Building Permit Application

Permit No.: P16000812

RE: **B16000812**
11954 Queen Street
Fulton, MD 20759

This letter is in response to building permit **B16000812**. The building permit application describes a *2-story addition*. Upon review the building permit and site plan, the submittal did not include a copy of the floor plans of the existing house plus proposed changes. The house floor plan (basement, first and second floor) may be hand drawn. Floor plans are necessary to determine if the onsite septic system is sized properly for existing plus proposed number of bedrooms (See attached definition of a bedroom). Additionally, the site plan must include all septic system components (tank, trench and septic reserve area) to ensure setback requirements are being met.

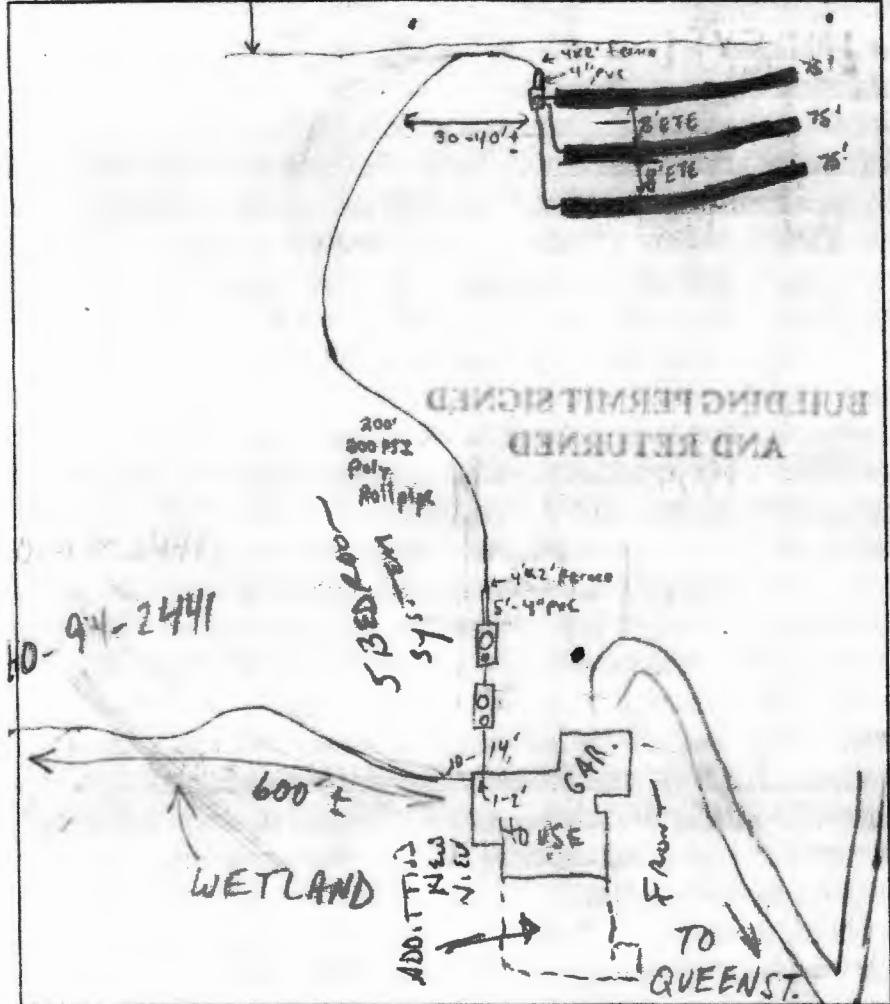
Ex. Buried Power line to be disconnected - new prop. location of power line
